POINT BEACH NUCLEAR PLANT, UNIT NO. 2

AMENDMENT TO FACILITY OPERATING LICENSE

Amendment No. 18  
License No. DPR-27

CHANGE NO. 24 TO THE TECHNICAL SPECIFICATIONS

FIGURE 15.3.10-3  
HOT CHANNEL FACTOR NORMALIZED  
OPERATING ENVELOPE

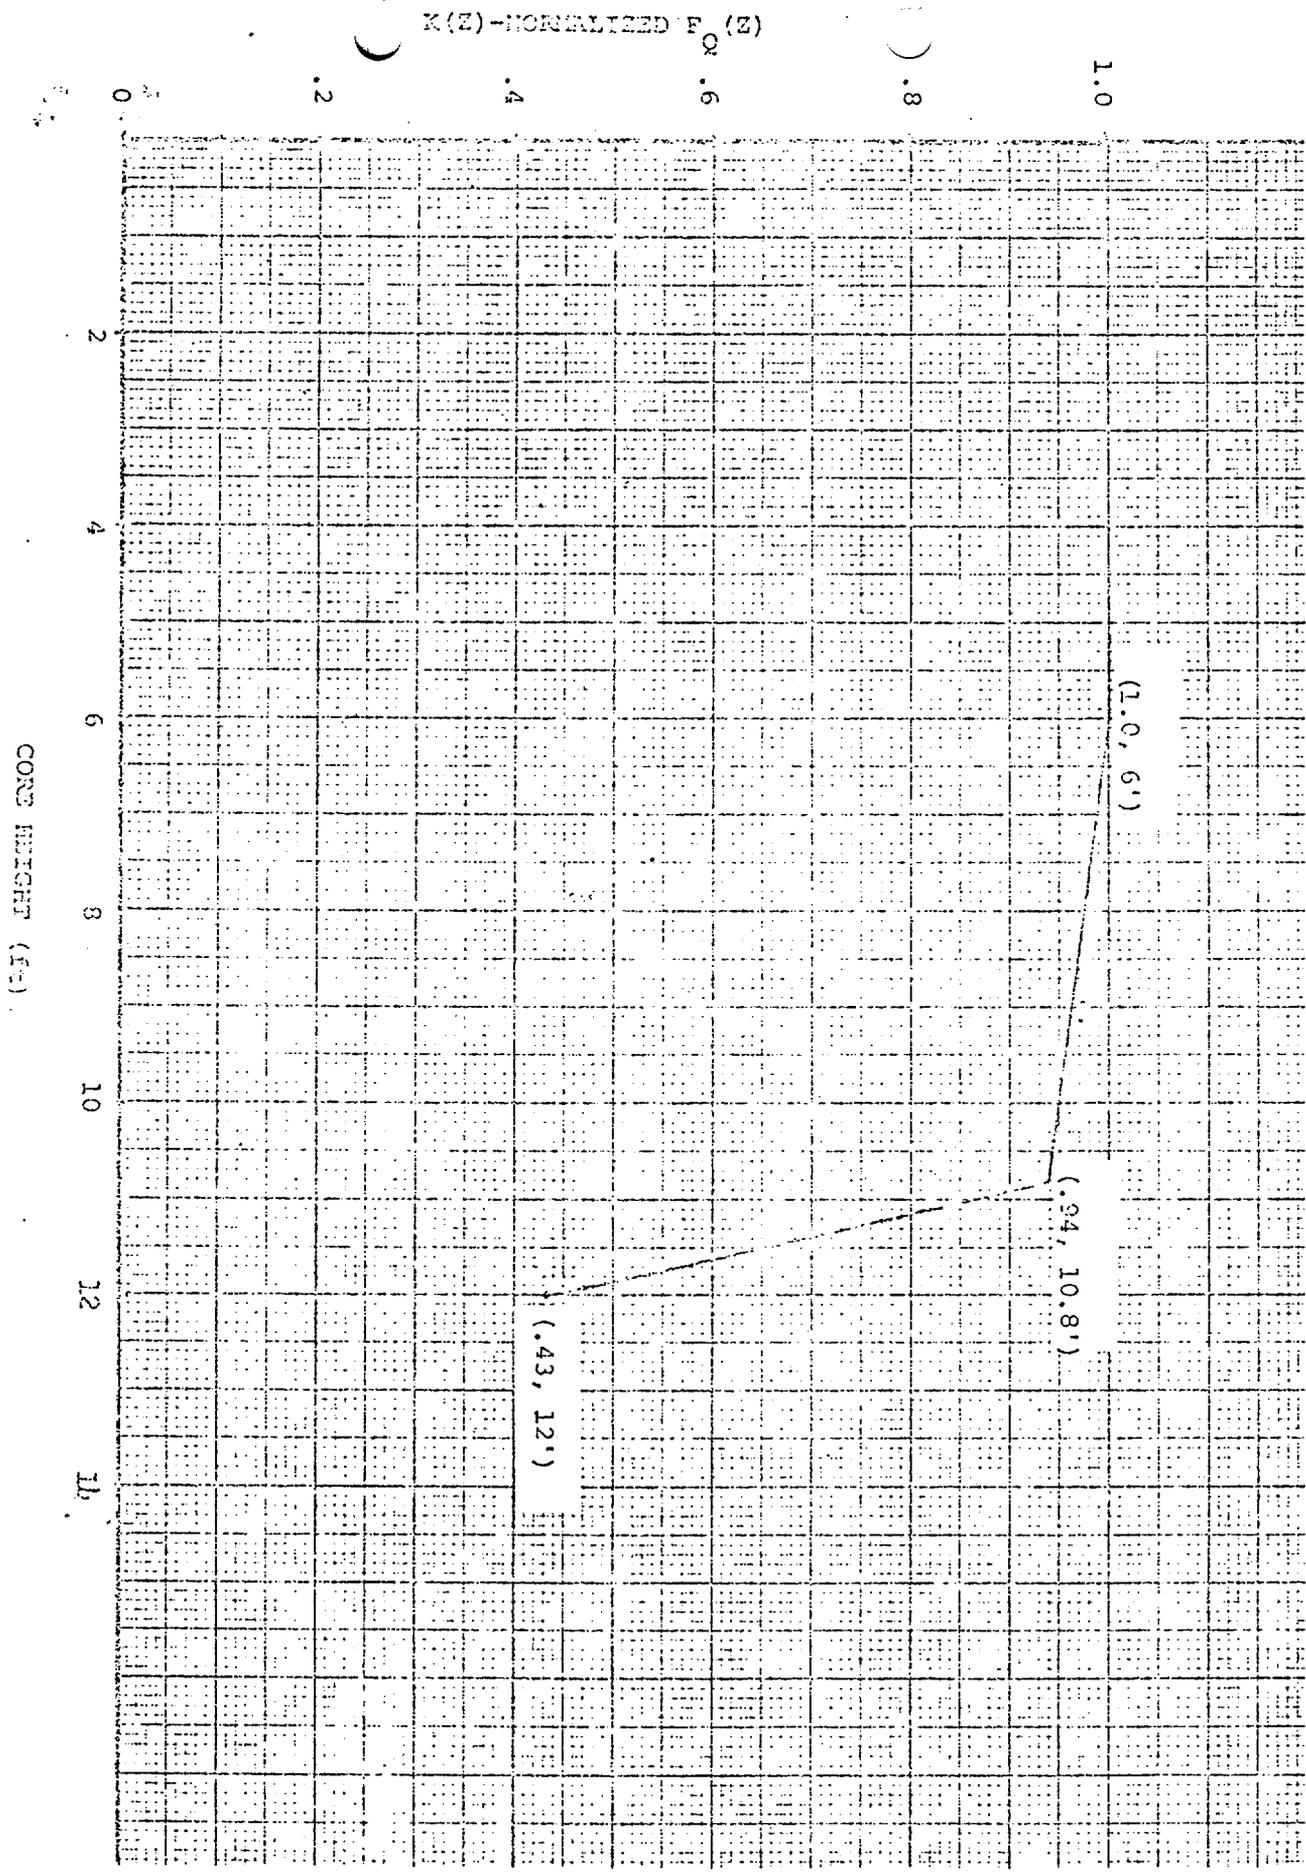
Replace page 15.3.3-1, page 15.3.3-2, pages 15.3.10-1 through 15.3.10-13, and Figure 15.3.10-3 with the attached revised pages. Add page 15.3.3-2a, page 15.3.10-14, and page 15.3.10-15.

where P is the fraction of full power at which the core is operating, K(Z) is the function in Figure 15.3.10-3 and Z is the core height location of F<sub>Q</sub>.

An upper bound envelope of 2.32 times the normalized peaking factor axial dependence of figure 15.3.10-3 consistent with the Technical Specifications on power distribution control as given in section 15.3.10 was used in the LOCA analysis. The results of the analyses based on this upper bound envelope indicate a peak clad temperature of 1996°F corresponding to a 204°F margin to the 2200°F limit.
